GISBORNE WASTEWATER NETWORK – OVERFLOW DISCHARGES: REGULATORY REF: DW-2020-109732-00/WD-2020-109733-00

Further S92 Response 21 April 2021

Pipe Height: 374.00

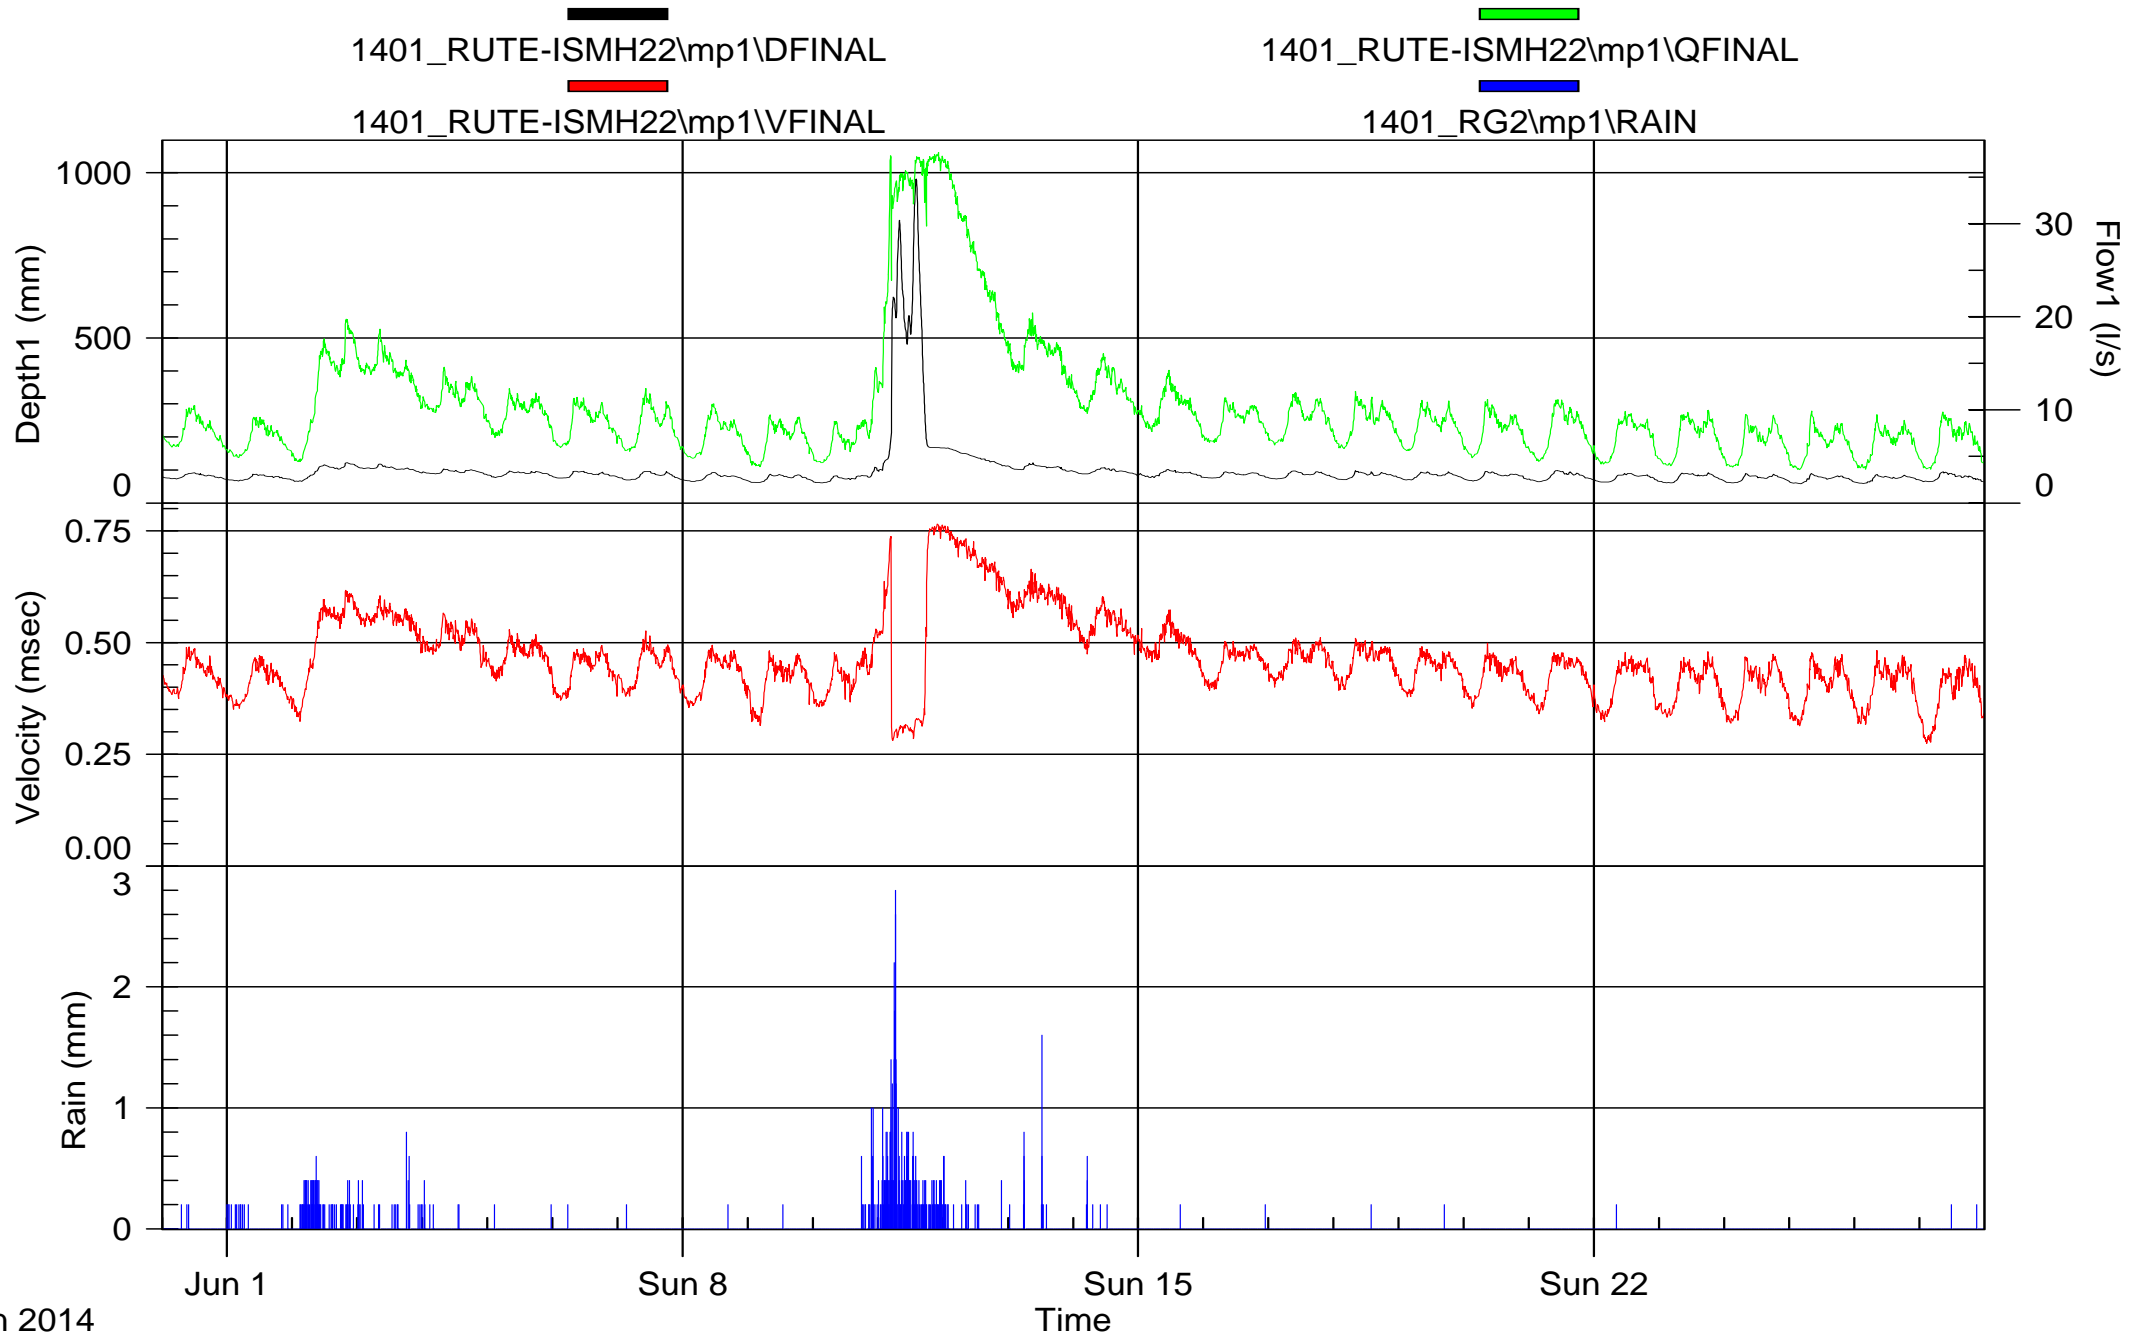
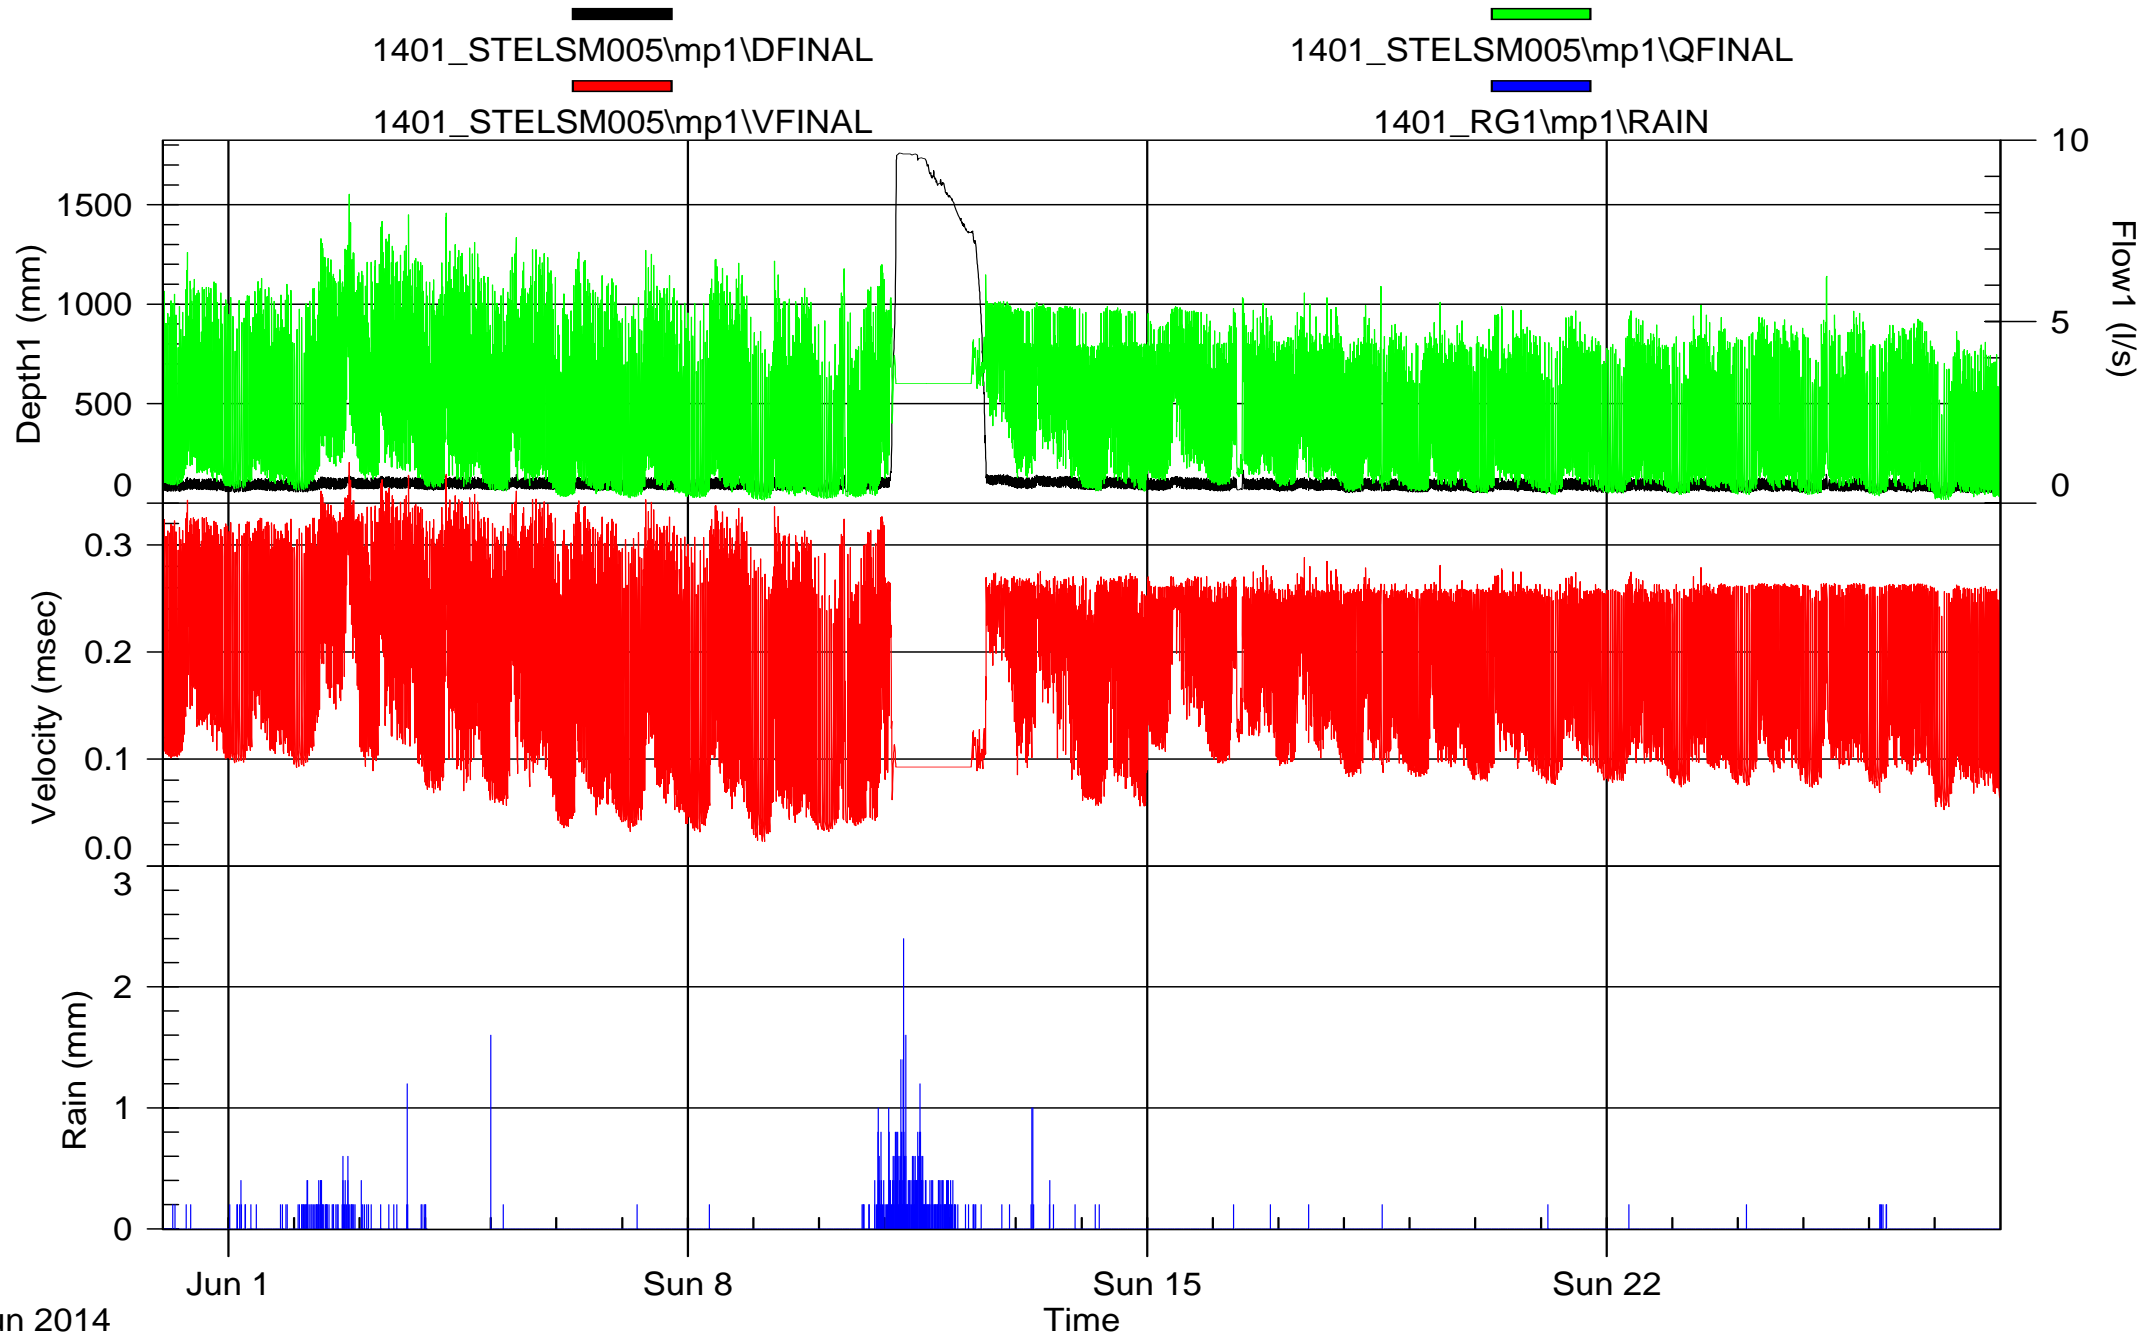
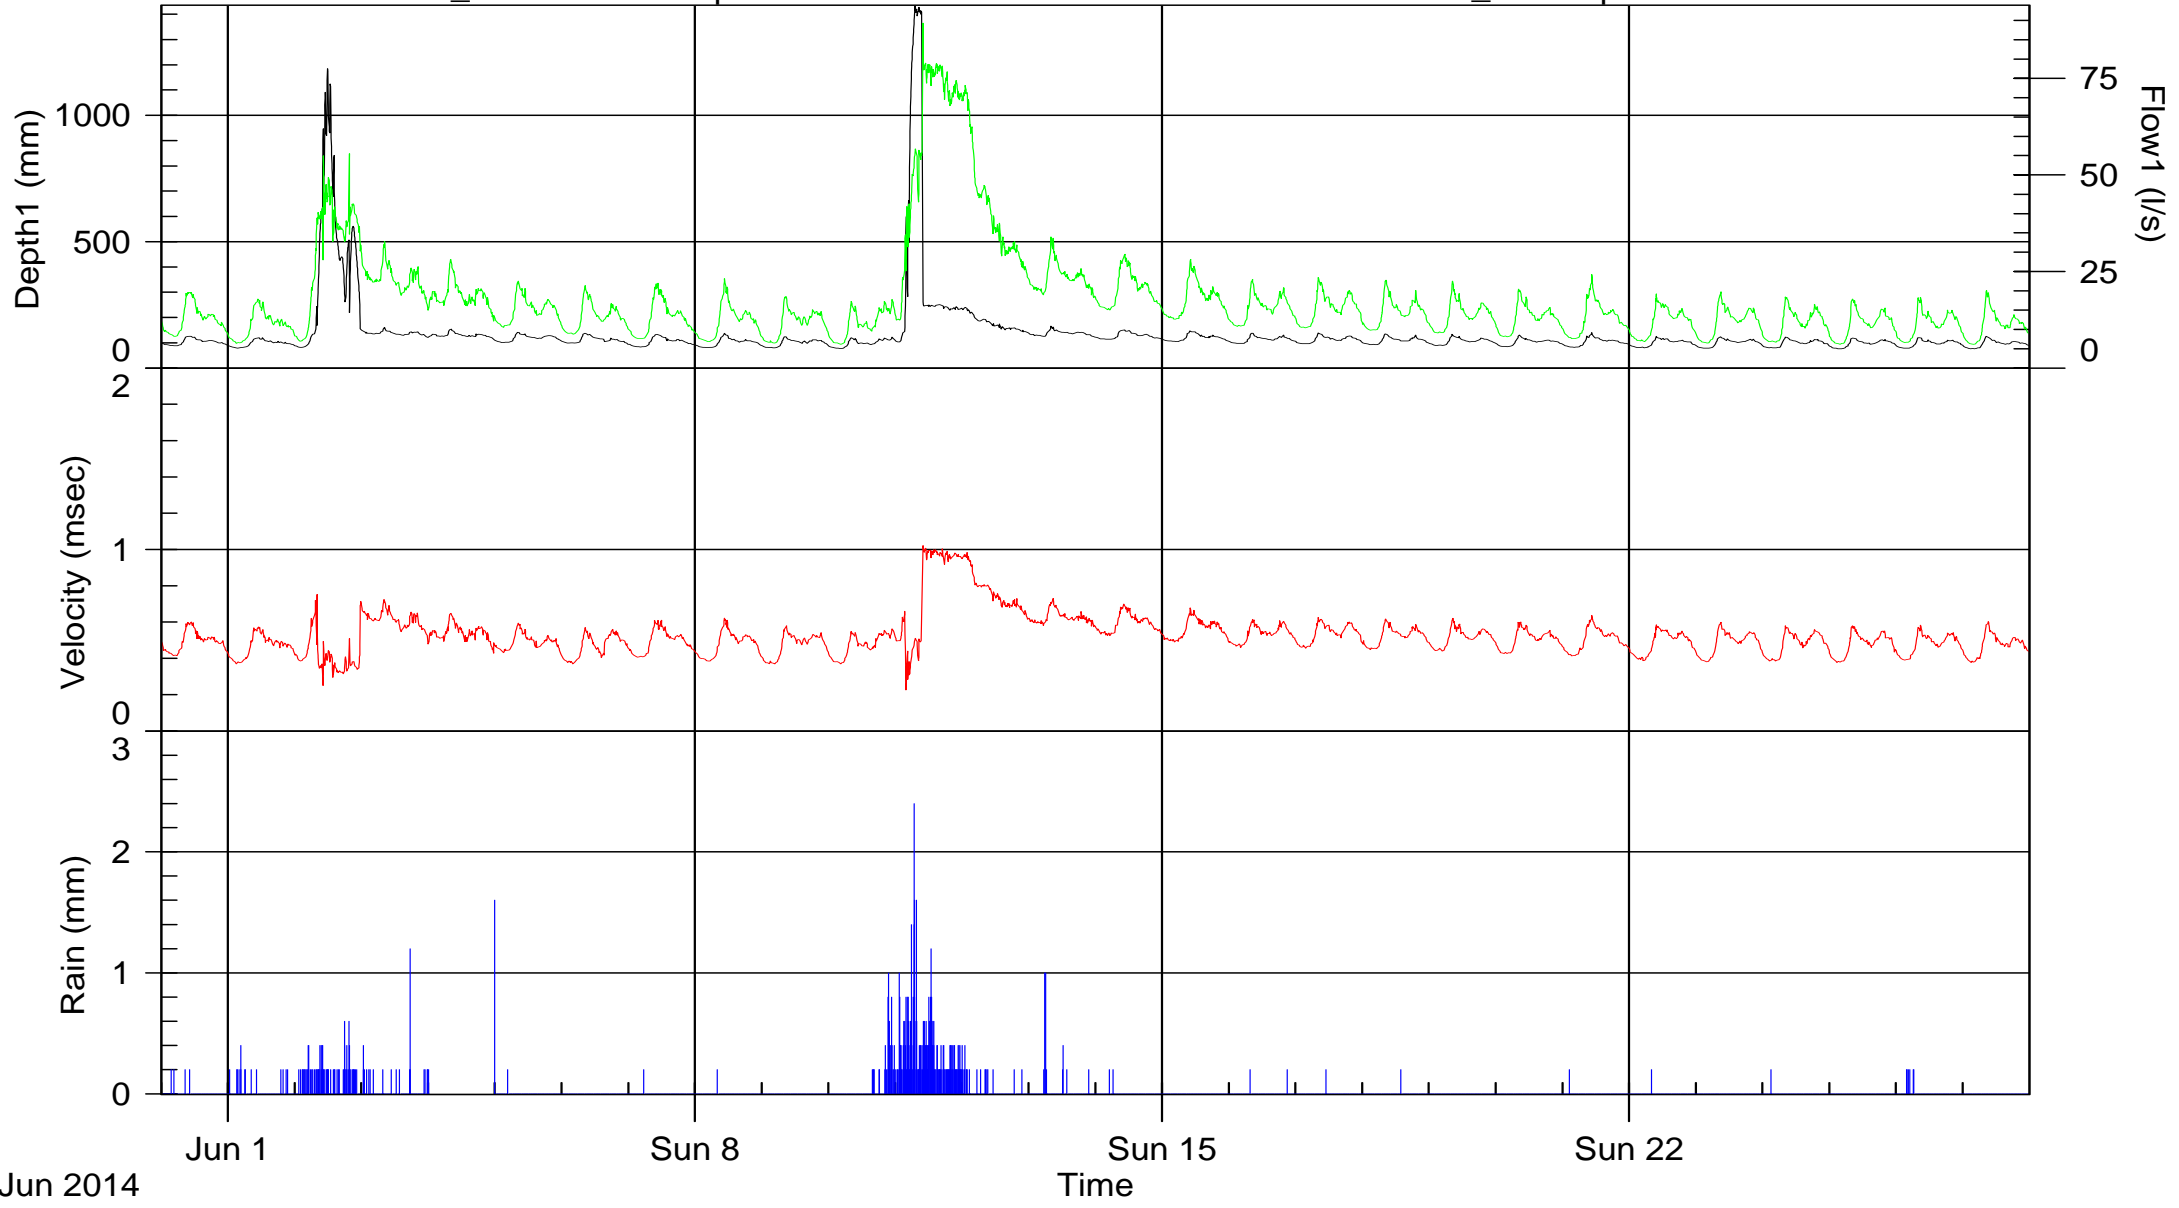
<p>upstream wastewater network including pump stations and reference (from the Mott Macdonald gauging report) which locations/hydrographs one(s) show the fast response to direct inflow?</p>	<p>We have also extracted flow monitoring information from the Mott Macdonald report for June 2014 (Attachment B) to facilitate review of the network flow monitoring across the monitoring sites. As can be seen from this extract, all of the monitoring sites show rapid response to heavy rainfall. Some sites to the south of the Taruheru River (eg APNISM135, DISRSM125 and LYTTSM075) also show the influence of overflow valves being opened from 11 to 12 June 2014.</p>
<p>b. Can the applicant provide a map/schematic that show areas of known property flooding referenced in the original application, page 223, see Figure 3-2 from the CH2M Beca Modelling Report, 2017. How does this compare to the nodes identified as flooding in the 2yr-ARI map (Figure B2) in the Beca modelling report.</p>	<p>A map showing indicative property ponding is provided below.</p> <p>The 'Ponding Likelihood' layer predicts where water is likely to pond on a property, based on a number of GIS layers that have been aggregated through a weighting process. These GIS layers include our stormwater flood model, depressions layer, and a Rain on Grid model.</p> <p>Ponding can be affected by many factors, e.g. fences on a property may divert flows, private stormwater sumps and pipes may drain areas, and soil conditions may allow for water to seep into the soil quicker than modelled. The data is also relevant to information available at a specific point in time, and things may have changed over time. Therefore, this layer is viewed as a guide only, as site conditions could be different.</p> <p>The modelled information is based on geospatial modelling, is for indicative purposes only. Council also uses records of actual flooding (surveys and Requests for Service received) and undertakes property inspections / investigations to validate whether or not there are actual effects, and whether or not stormwater drainage improvements (public or private) are required to mitigate the risk of ponding.</p> <p>The nodes identified in Figure B2 have been overlain on the Ponding Likelihood' layer. However, the location of property flooding in heavy rainfall will not necessarily correlate to the location of wastewater overflows from manholes.</p> <p>While property flooding is considered a primary cause of rainwater entering the wastewater system, properties that experience wastewater overflows will not necessarily also be the properties that experience rainwater flooding. Property</p>

<p>c. Can the applicant please provide a <u>model calibration report</u>. This should include a comparison between predicted/modelled flows and gauged data and demonstrate how well the model performs. This is required to determine the level of confidence in the modelling results (and subsequent conclusions).</p>	<p>No specific calibration report was produced. The flow gauge data and model graphs were part of the calibration process as is standard practice. The model aims to reflect the AWT flow gauging report that shows rainfall and the resultant wastewater flows that occur very quickly afterwards. As indicated in our previous response, the flow gauging sites were selected with a key aim of calibrating the model to predict overflow performance. The flow records show rapid and substantial increases in wastewater network flows associated with rainfall events and this is a clear demonstration of the result of direct stormwater inflow (Fast Response), which is replicated in the wastewater model.</p>
